Ref: R.18-10-007

RE: MUSSEY GRADE ROAD ALLIANCE COMMENTS ON 2020 WILDFIRE MITIGATION PLANS OF SDG&E, PG&E, SCE

WILDFIRE MITIGATION PLAN COMMENTS ON BEHALF OF THE MUSSEY GRADE ROAD ALLIANCE

Figure 13 - SCE top risk ranked circuits¹¹⁵ overlaid on its 99% wind map.

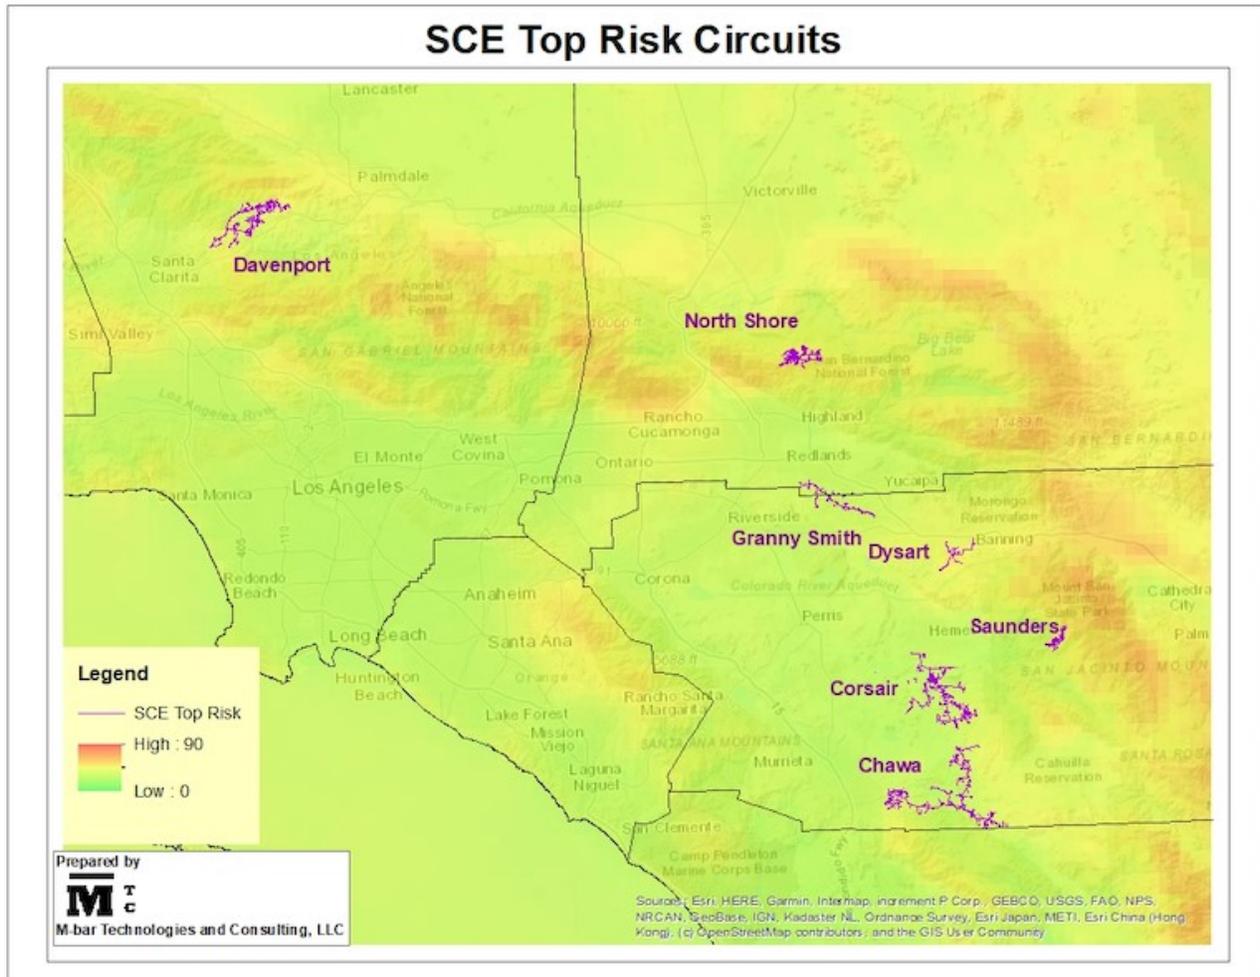
SCE's top ranked risk circuits mostly extend into or abut its predicted high wind areas. The one exception is the Granny Smith circuit, south of Redlands.

Figure 14 - SDG&E top ranked risk circuits¹¹⁶ overlaid on its 99% wind gust data and wind loading zones.

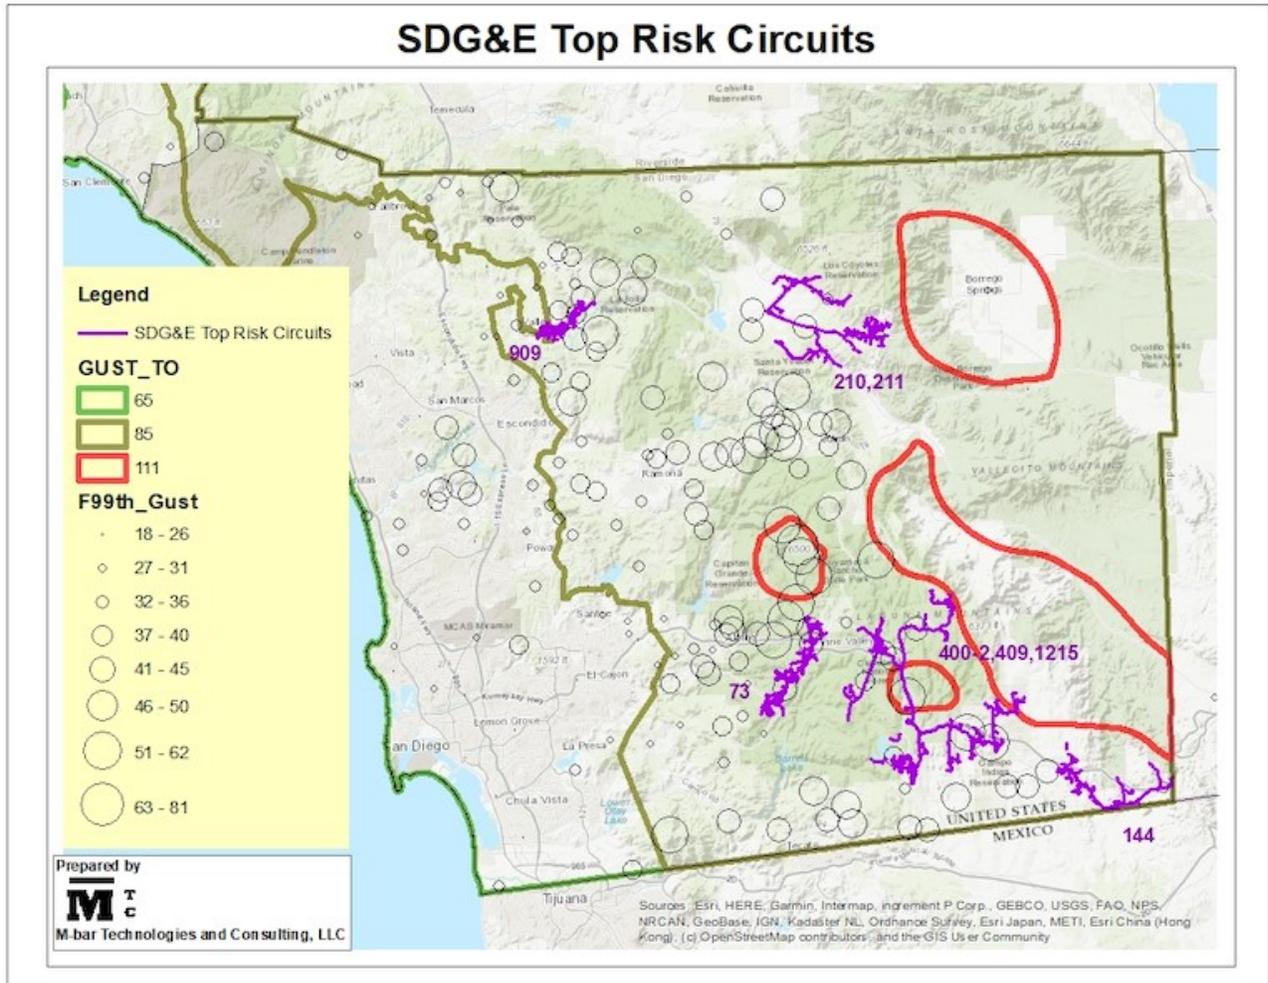
SDG&E's top ranked risk circuits mostly extend into or abut areas where weather stations measure high speeds or extreme wind loading districts. There are two exceptions: Circuit 144, in the far southeastern corner of San Diego County, and circuits 210 and 211, near Warner Springs. It should be noted that SDG&E has had an extensive hardening program in place for several years, and many of the most extreme wind areas may have already been addressed.

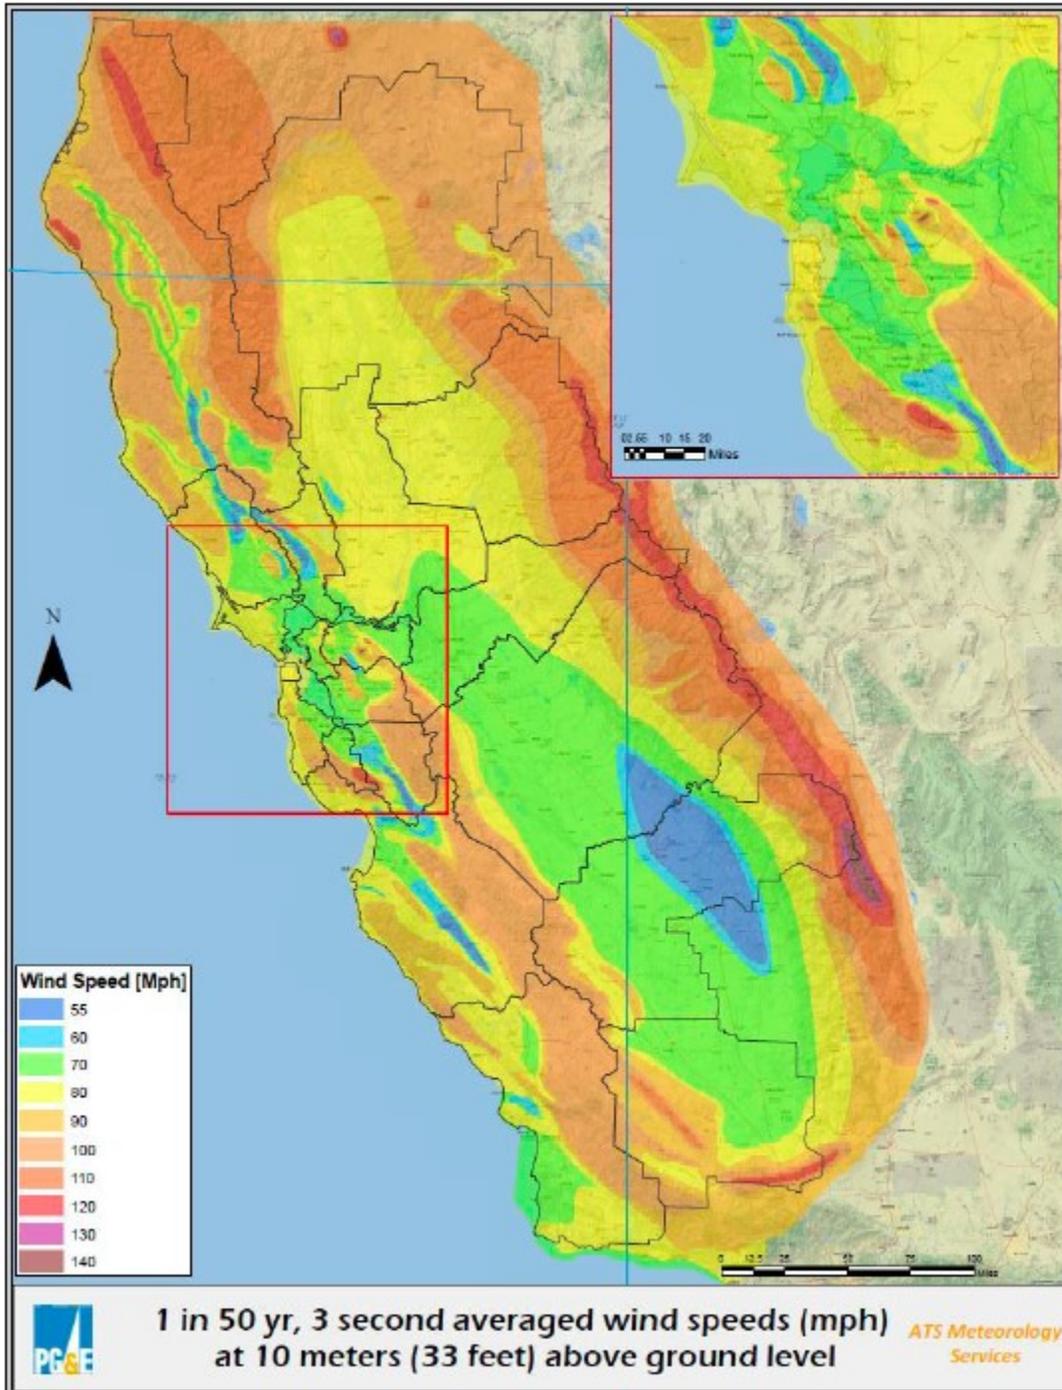
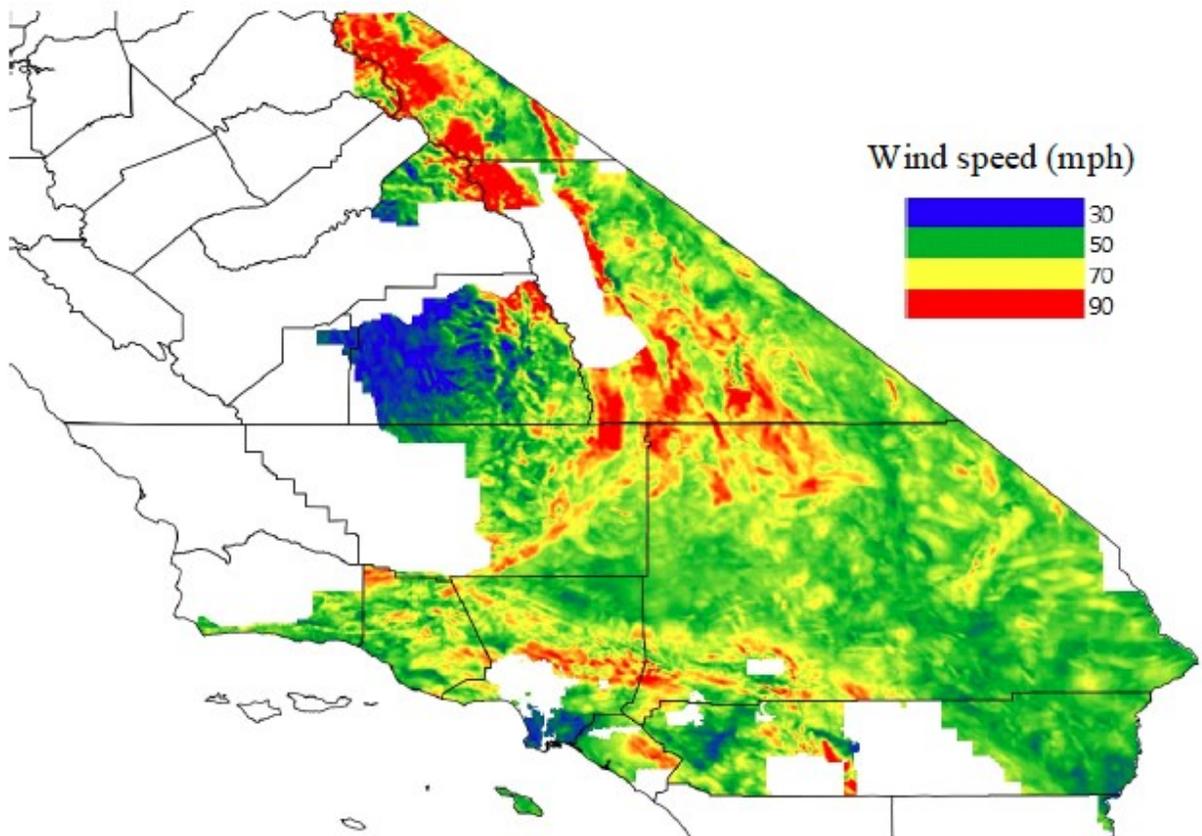
These studies make it clear that wind speeds are expected to regularly exceed 56 mph, the loading standard that IOUs historically built to, over vast swaths of utility service areas.

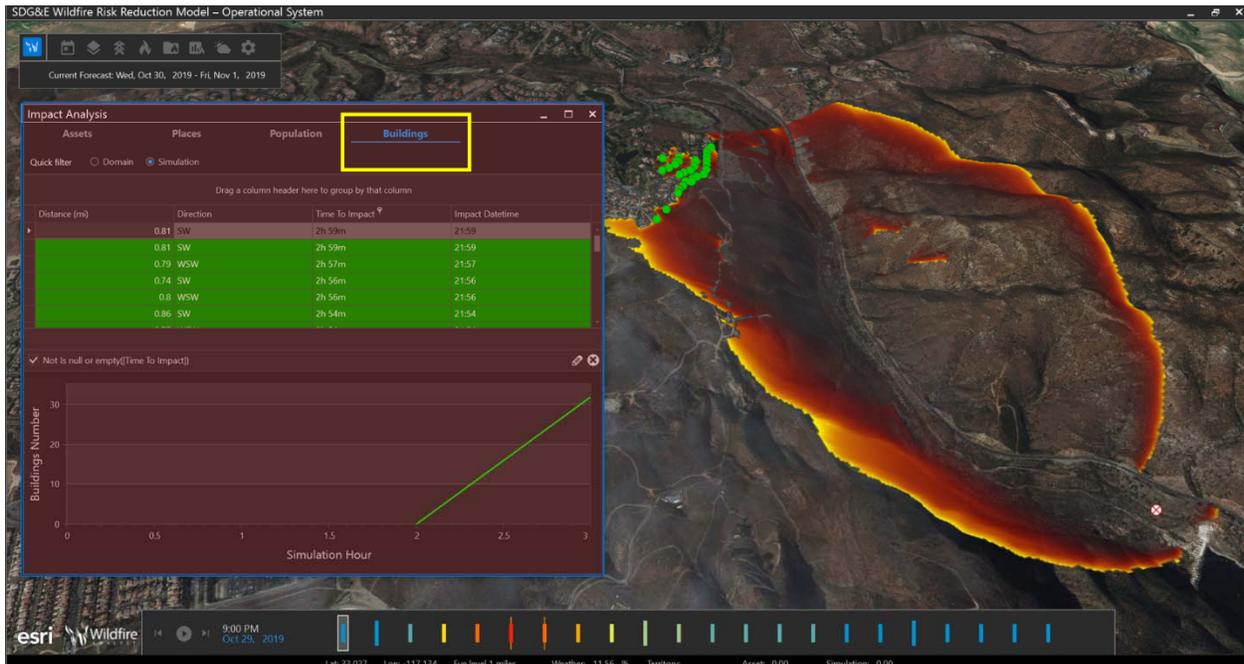
In Chapter 5, Figure 5 appears identical to Figure 6. Is this supposed to be the case and if not please provide a corrected figure.

Regarding Figure 5 and Figure 6 in SDG&E's 2020 WMP, Figure 5 was inadvertently duplicated in Figure 6. The correct Figure 6 is provided below. SDG&E will inform Wildfire Safety Division and parties of this errata in its WMP weekly update email and will coordinate with the Wildfire Safety Division on when to formally incorporate this corrected figure into its WMP.
